BOS BLOCK 1 Full Work Group Response

Presentation to: Massport CAC

Date: October 18, 2018

RWY 15R Transition (TXN) current and notional designs with recent radar tracks

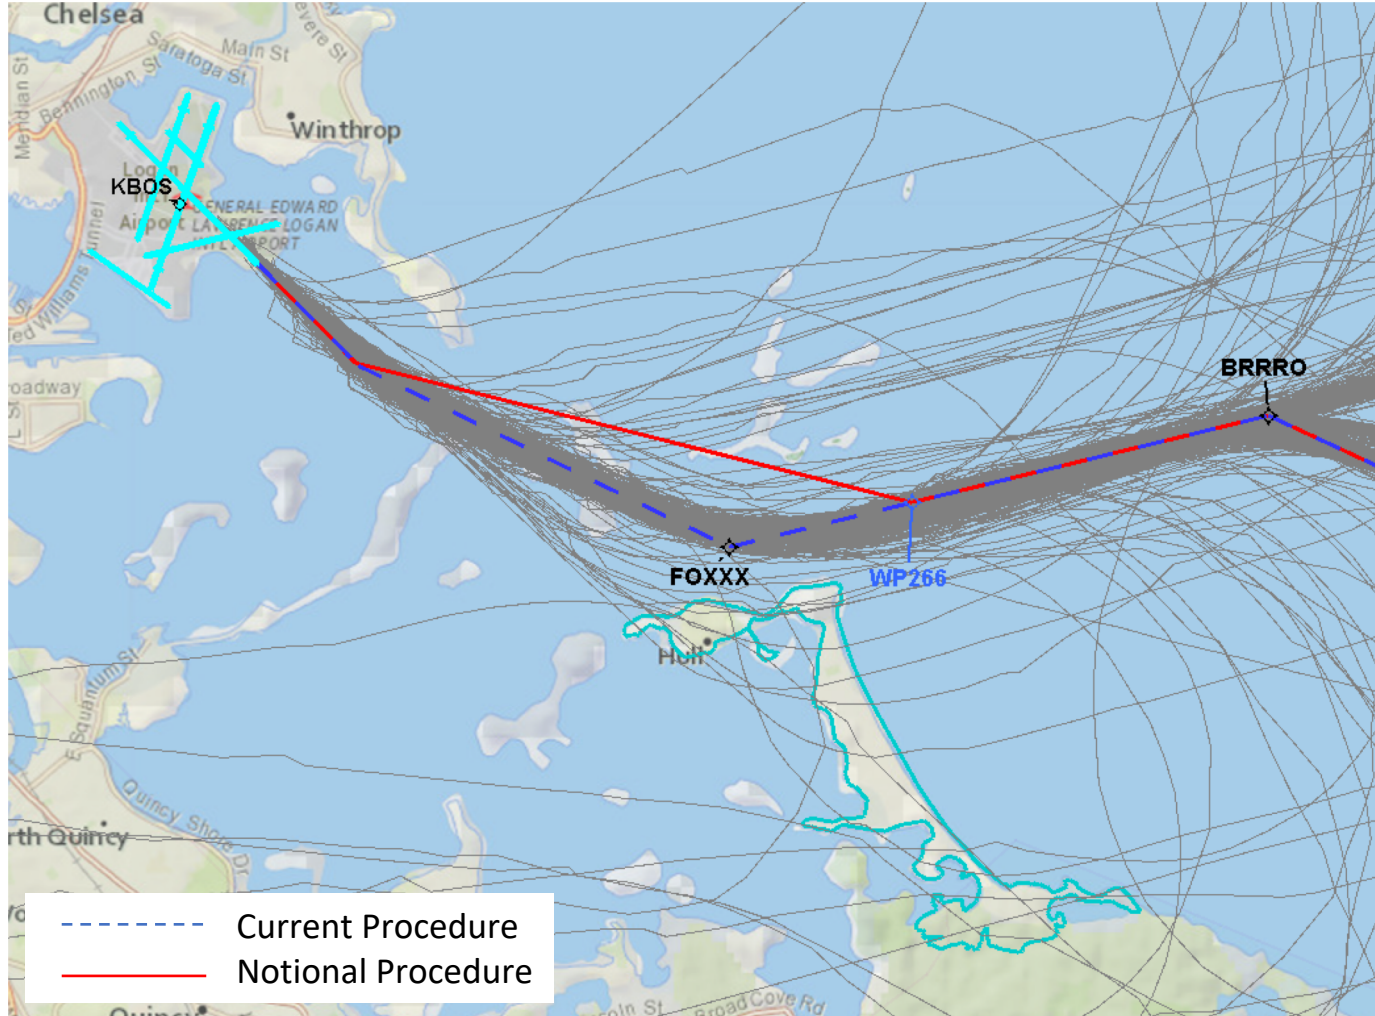
Modify RNAV SID from Runway 15R to move tracks further to the north away from populated areas.

Design recommended by MIT

Notional design by Full Work Group as of October 4, 2018

MIT Estimates RWY 15R TXN Modification

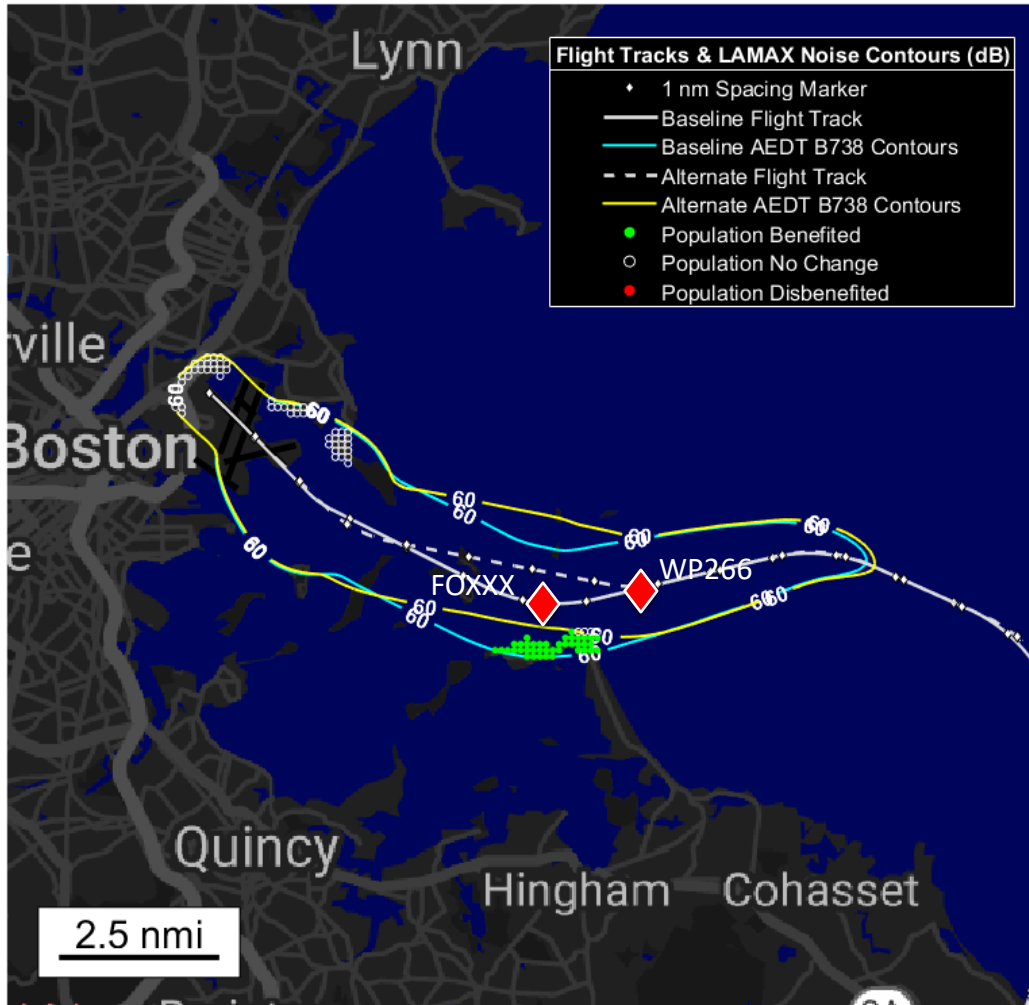
B737-800 60dB $L_{A,max}$ Noise Exposure

60dB
Current RNAV	5,838
.41 RNAV	4,815
Difference (Current RNAV – .41 RNAV)	1,023

Option A: Climb to intercept course (VI-CF) procedure

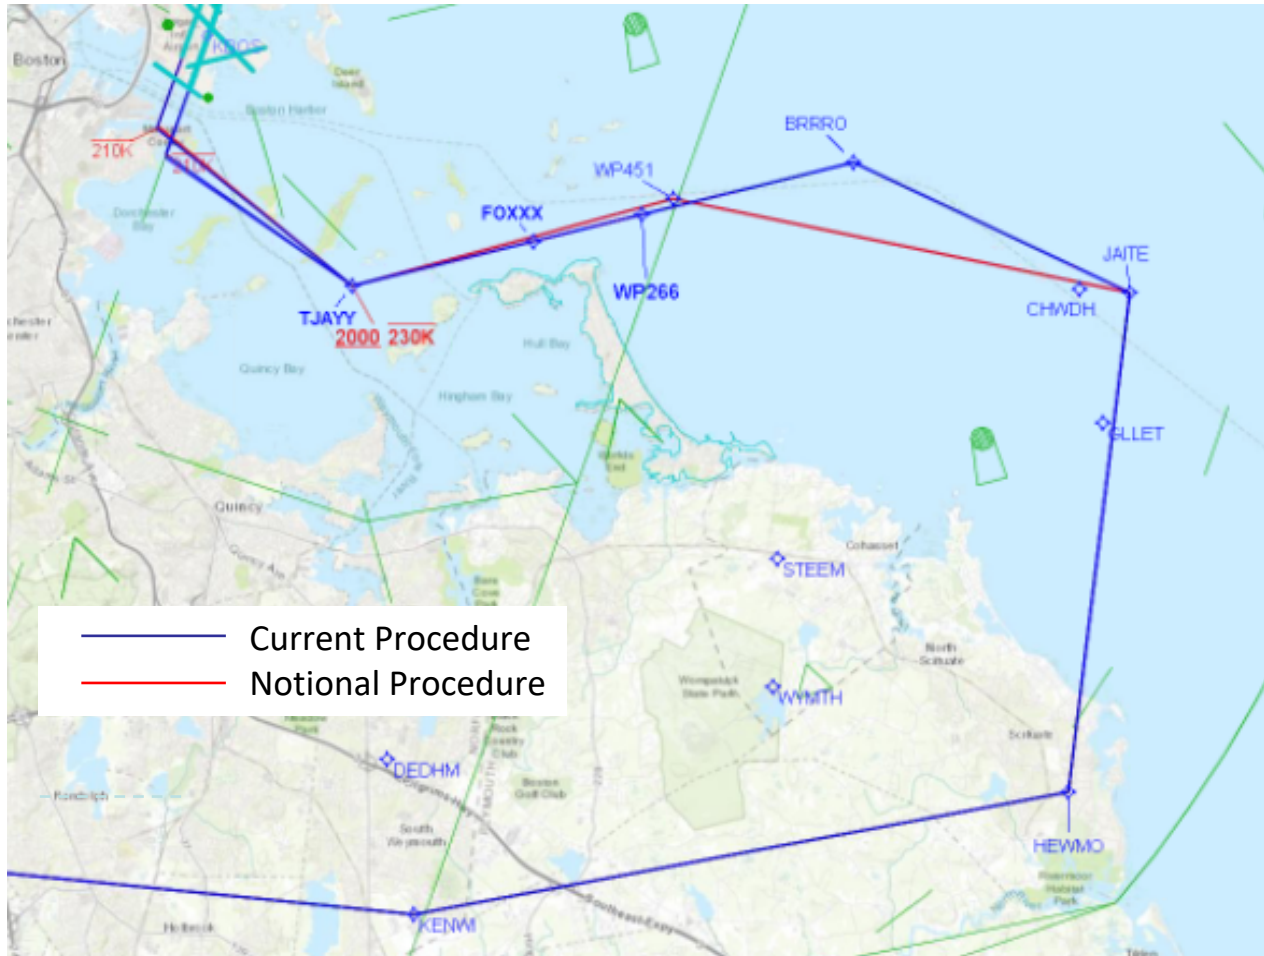
- ❖ RWY 27 arrival separation requirements keep RWY22 transitions from moving further north
- ❖ Unable to move track further from HULL
- ❖ Shoreline crossing north of HEWMO would be at lower altitude
- ❖ Original designs were not flyable
- ❖ Current designs are the result of extensive study by industry and the FAA with the intent to be as far away from Hull as possible
- ❖ After extensive review by the FWG, no further design changes are feasible

- ❖ **Aircraft navigational limitations resulted in termination of the earlier VA-DF procedure in 2011**
 - ❑ 2011 MITRE study confirmed aircraft navigational limitations
 - ❑ Meetings with Industry resulted in recommendation of VI-CF procedures
 - ❑ VI-CF procedures were developed and currently in use

- ❖ **Wide splay of aircraft tracks were rejected by community**
 - ❑ There were numerous community complaints from South Boston and Hull that aircraft were too close/overflying the communities
 - ❑ 2011 HMMH study commissioned by Massport confirmed wide splay of aircraft tracks; Recommended VI-CF procedures to correct
 - ❑ VI-CF procedures were developed and currently in use

- ❖ **The current Work Group reviewed the VA-DF option and determined Runway heading to 520ft prior to turning to the first waypoint is not feasible**
 - ❑ Would cause heavy/low performing aircraft to fly over Hull due to delayed turns because of slower climb rates

- ❖ **Increases verbiage between Local Control, Departure Control and pilots**
- ❖ **Increases probability of readback/hearback errors, a safety issue**
- ❖ **Shortening departure paths cause conflicts with ROBUC STAR, particularly with heavy/low performing aircraft**
- ❖ **Current procedures from 4R, 9, 15R, 22R/22L provided noise benefits to shoreline communities**
- ❖ **Logan CAC requested RNAV SID departures in lieu of vector based procedures**

RNAV (RNP) RWY33L with RNAV VISUAL

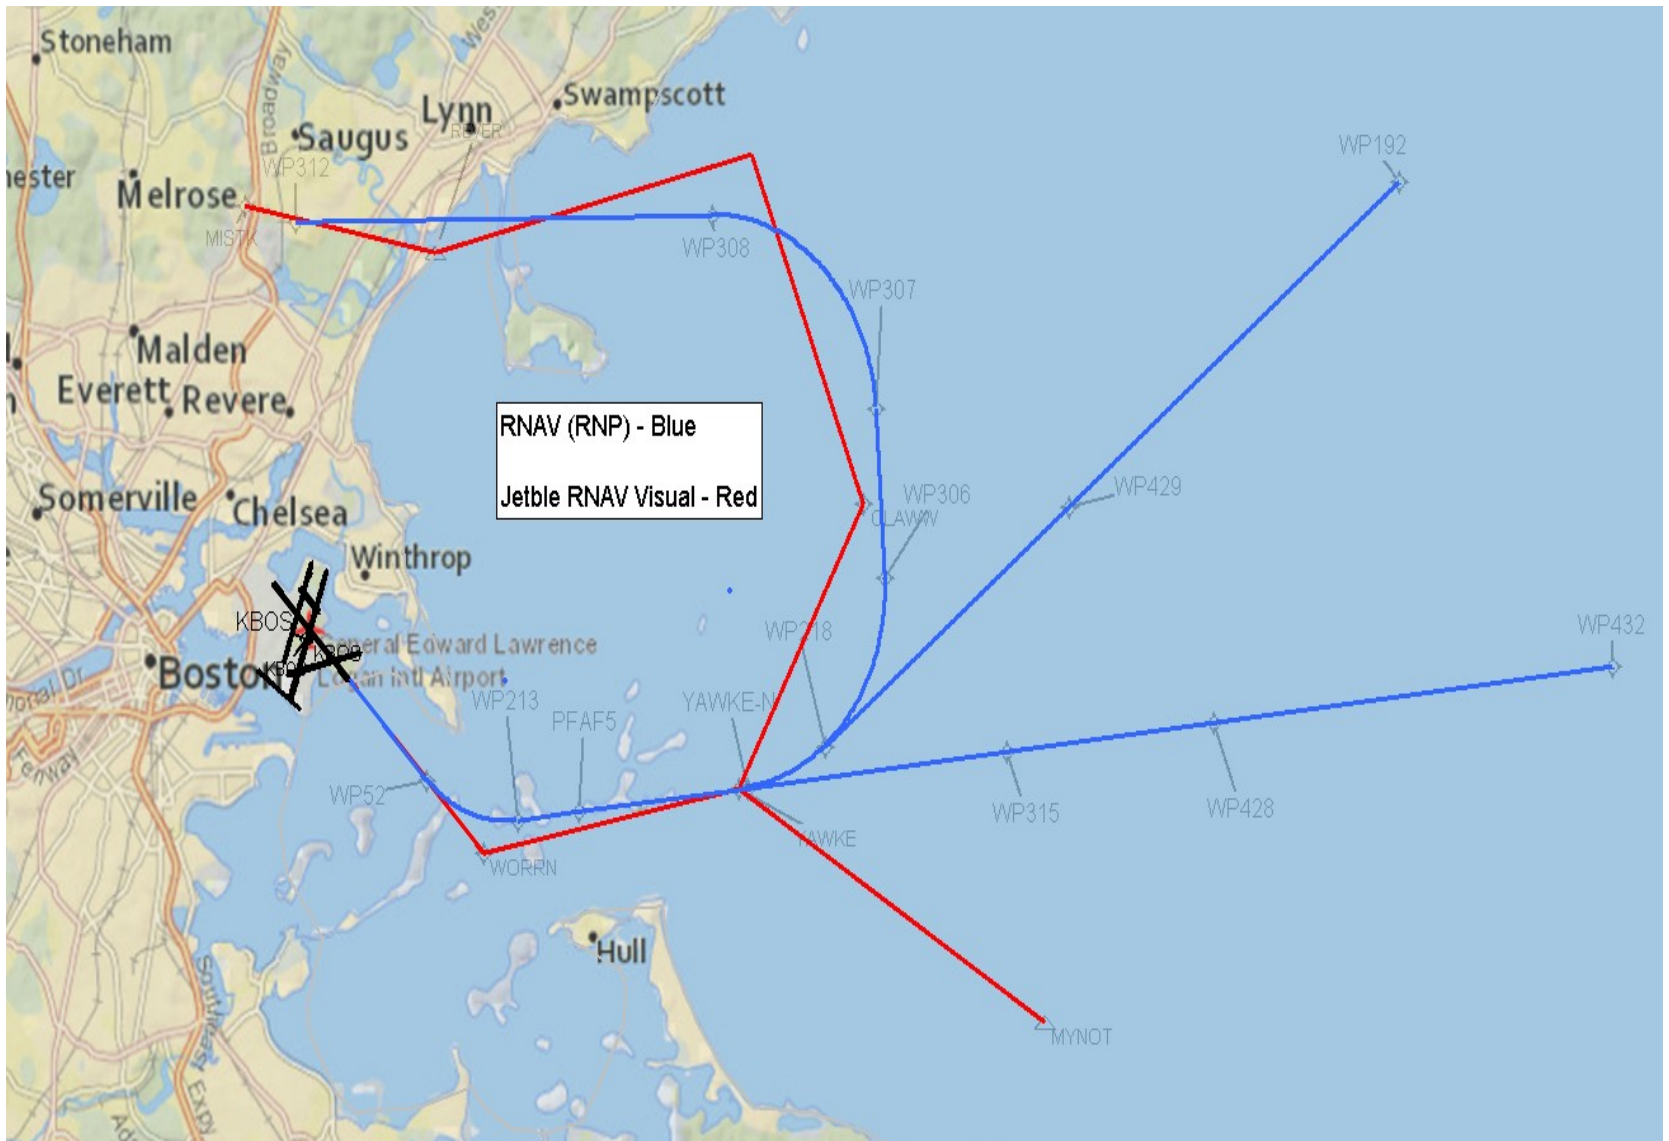
Implement an over water RNAV approach procedure with RNP overlay to Runway 33L that follows the ground track of the JetBlue RNAV Visual procedure as closely as possible

- ❖ **OBJECTIVE - Mirror the ROBUC, JFUND and OOSHN RNAV STARs with runway transitions that connect to RNAV approaches developed during evaluation of the Block 1 recommendations**

- ❖ **New Nocturnal STARs**
 - ❑ LUNAA (RNAV) STAR (mirrors ROBUC)
 - ❑ BUNNT (RNAV) STAR (mirrors JFUND)
 - ❑ CGURL (RNAV) STAR (mirrors OOSHN)

MIT Noise Evaluation of RNAV (RNP) RWY 33L Notional Design

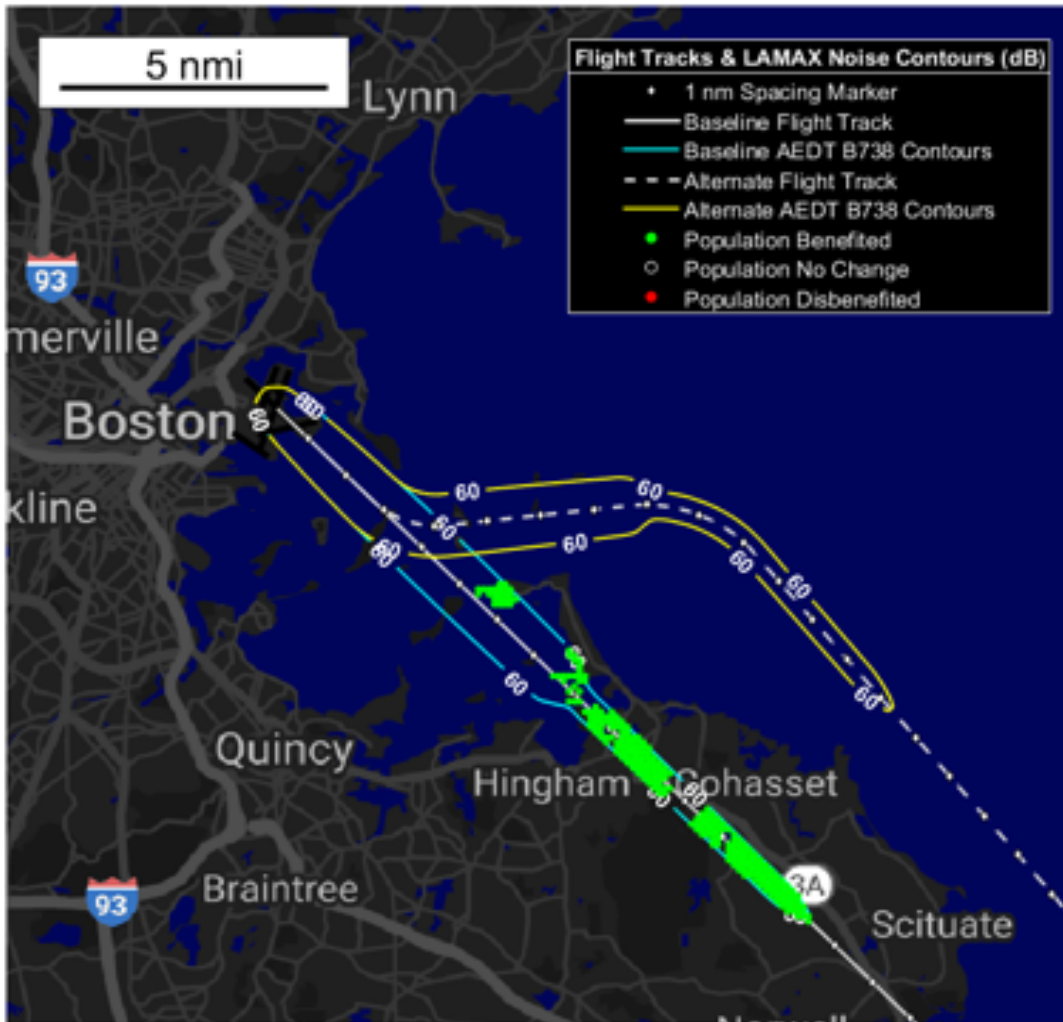
B737-800 60dB $L_{A,max}$
Population Exposure

60dB
Straight In	2,954
RNP	0
Difference (Straight In – RNP)	2,954

RNAV (GPS) RWY 33L Approach Versions 6 and 7

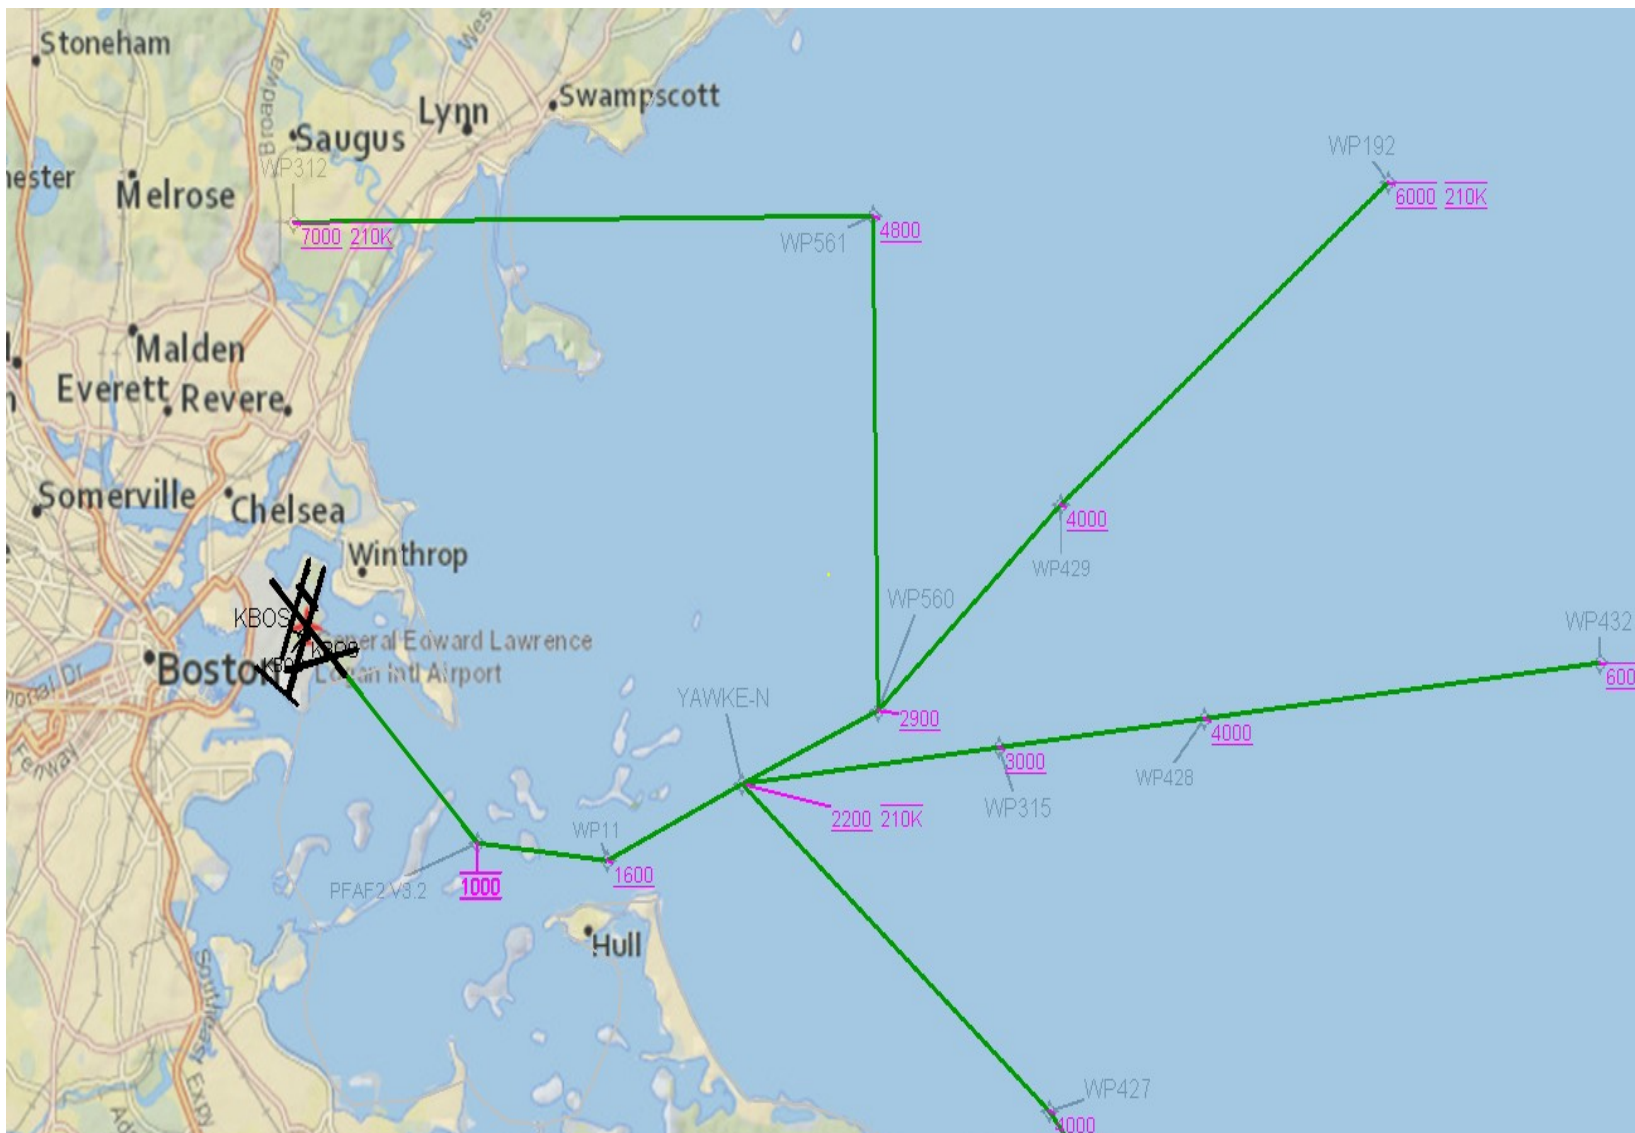
- ❖ Both version were proposed by Industry during collaborative Work Group meetings
- ❖ Were attempts to mimic Jet Blue Special RNAV Visual while meeting safety standards for RNAV GPS public procedures
- ❖ The tracks moved close to or over Hull (version 6)
- ❖ Moving the tracks created safety issues with obstructions (version 7)

RNAV (GPS) RWY 33L With RNAV Visual

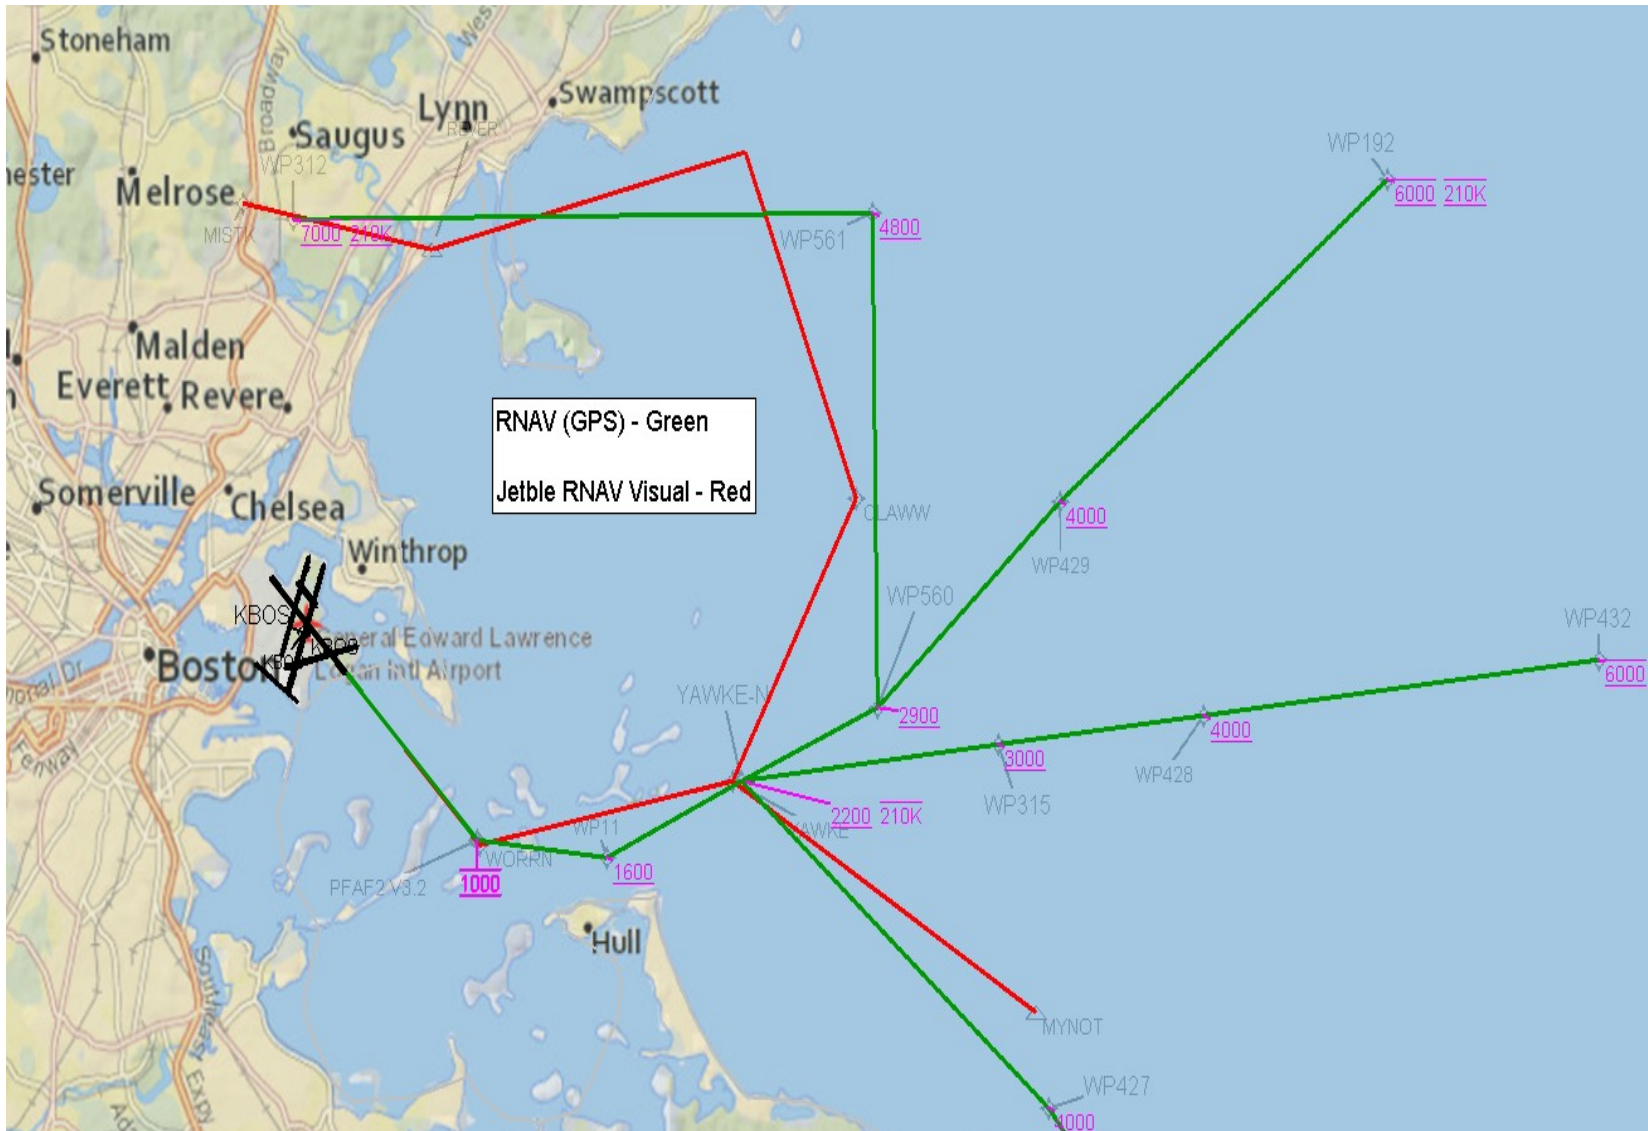
- ❖ **Procedure was developed and flight inspected**
- ❖ **Flight Standards office approved a waiver to allow the use of a 39° turn on final for this procedure**
- ❖ **Was reviewed by Massport and Community Advisory Committee**
- ❖ **Modifications currently being reviewed by Industry**
 - * Industry expressed that they will be unwilling to fly turns greater than the 39° in the final phase of flight, the maximum allowed
- ❖ **Prior to publication of the procedure, Massport and CAC asked the FAA to move route further from Hull**
